**TECHNICAL MEMORANDUM 004**  
**Phased Redevelopment of Governors Island South Island Development Zones**  
**Harbor School Annexes**  
**CEQR No. 11DME007M**  
**March 21, 2024**

**Re: SHPO ID# 15PR01662  
SCA's Response to LPC Comments Harbor School Annex**

DWG. TITLE  
**EXISTING AND PROPOSED  
BUILDING ELEVATIONS**

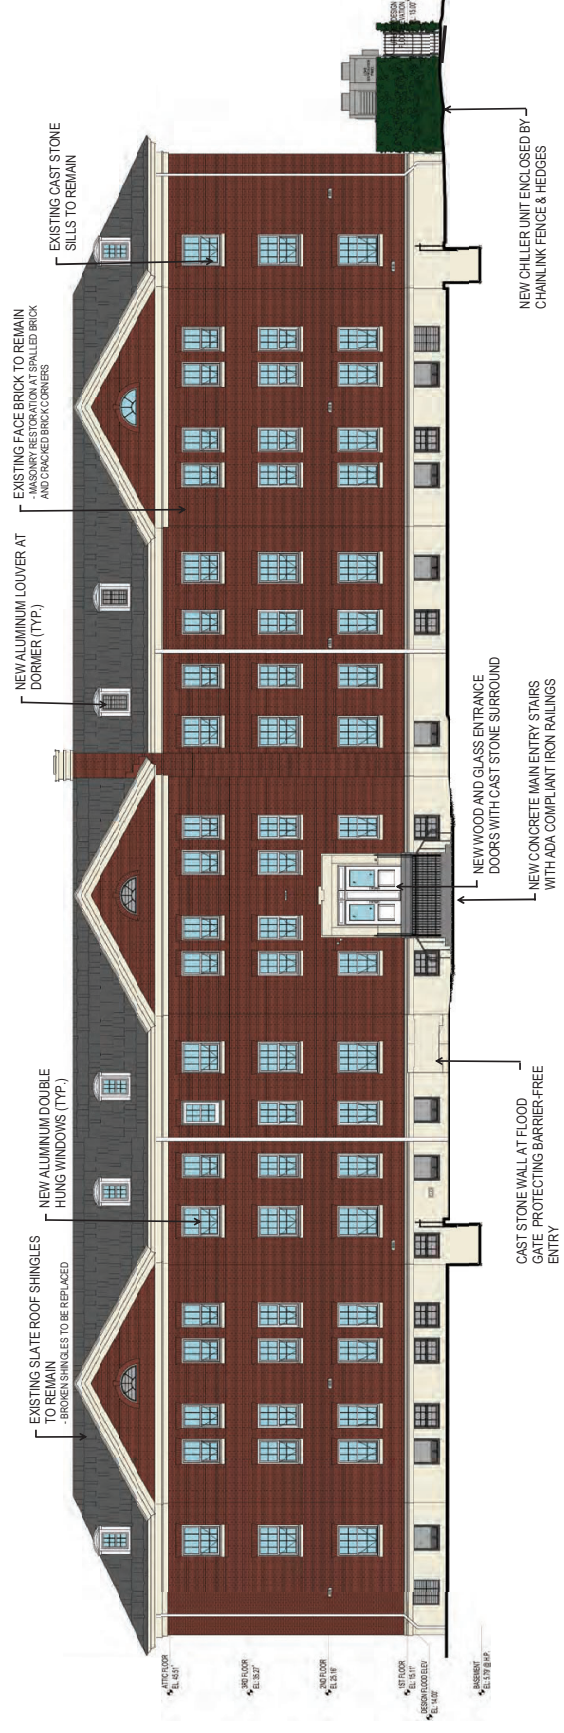
*LPC Comment: Brick and Cast Stone Screen Walls (at main entry stair and barrier-free access entrance).*

*LPC Comment: Main Entry Door and Barrier-Free Entrance Door Design*

The SCA agrees with the commissioner's comments about the material for the brick and cast stone screen walls. In response, the two walls are revised as follows:

1. The brick and cast stone wall located at the bottom of the new entrance stairs will be removed and replaced with a wrought iron guard rail and railing. (See attached Proposed Short Avenue Elevation and Enlarged Elevations drawing nos. 03 and 04).
2. The brick and cast stone wall at the entrance to the wheelchair lift will be revised to remove the face brick. The wall, which is required for the design of the flood gate, will be entirely cast stone. (See attached Proposed Short Avenue Elevation and Enlarged Elevations drawing nos. 03 and 04).
3. The face brick on the side walls of the new entrance stair will be removed. The side walls will be exposed concrete similar to the exposed concrete side walls at the three

existing exterior stairs at the historic front façade. (See attached Enlarged Elevations drawing no. 04 and Historic Front Photos no. 07).

1. The cast stone door surround will be raised to allow for a wood transom above each door. The configuration of the door and transom are consistent with the existing door and transoms at the historic front façade.
2. The height of the door and transom aligns with the height of the adjacent windows. (See attached Enlarged Elevations and Entrance Feature drawing nos. 04 and 05)

At the barrier-free access entry door to the wheelchair lift, the cast stone surround is reduced in size which improves the visual proportion of the cast stone, and which preserves the cast stone sill of the window above. (See attached Enlarged Elevations and Entrance Feature drawing nos. 04 and 05)

**DWG. TITLE**  
**NEW MAIN ENTRANCE - PROPOSED**

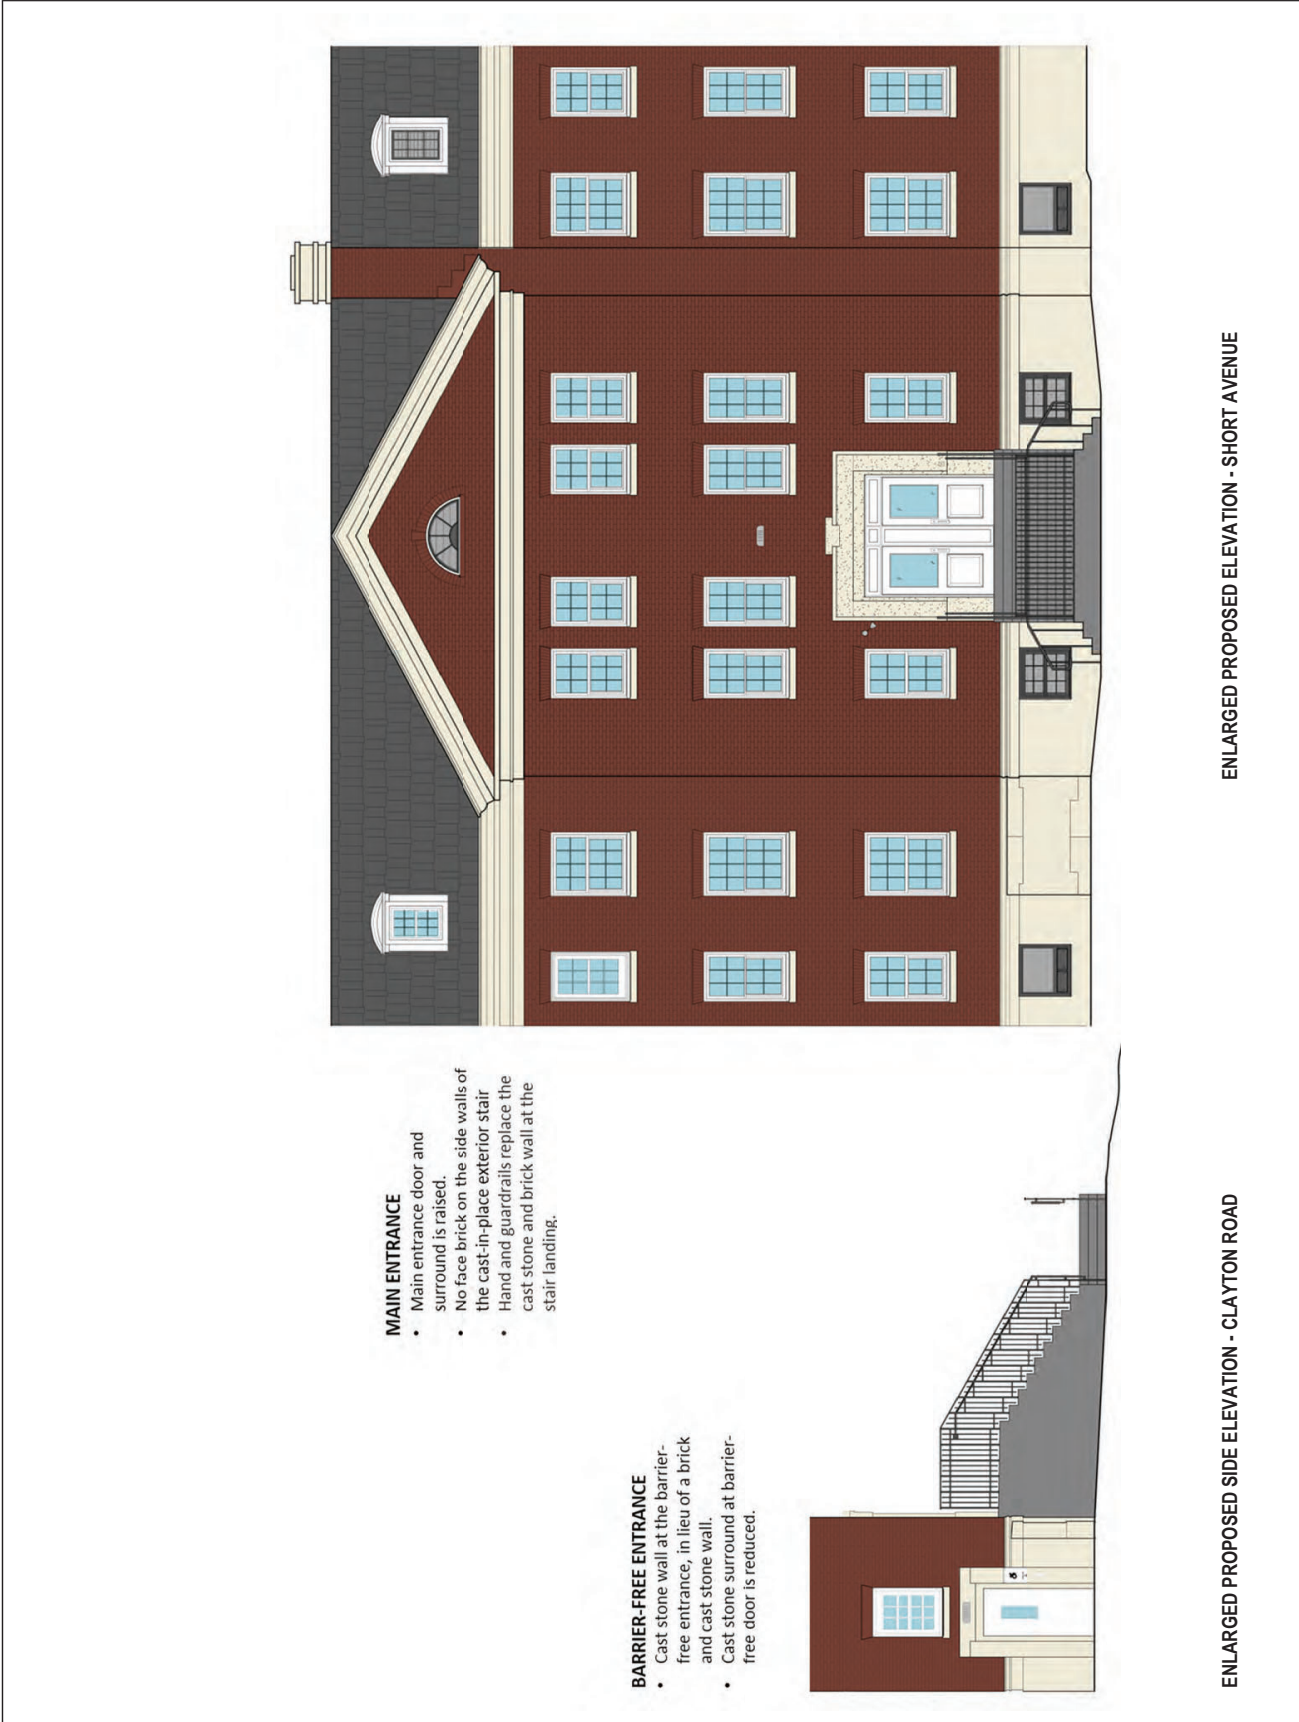
Additionally, these Commissioners expressed concerns about the proposed entry door surround details, noting that they would have a too subtle presence at this designed façade, with a few Commissioners recommending specific modifications to these details in order to establish more prominence at this new entry and its relationship to the façade, including: raising the height of the door headers to align with the adjacent window headers; cladding the center mullion of the new door assembly in a material other than cast stone; and revising the entry door surround details to harmonize more closely with existing door surrounds at the west façade. However, one Commissioner noted the New York State Historic Preservation Office's and U.S. Department of the Interior's requirements that the design and details of new ornamental features be differentiated from original historic details, and that the details and materiality at the entry door surrounds are appropriate as designed, while another Commissioner recommended omitting the surround entirely at the new barrier-free access door.
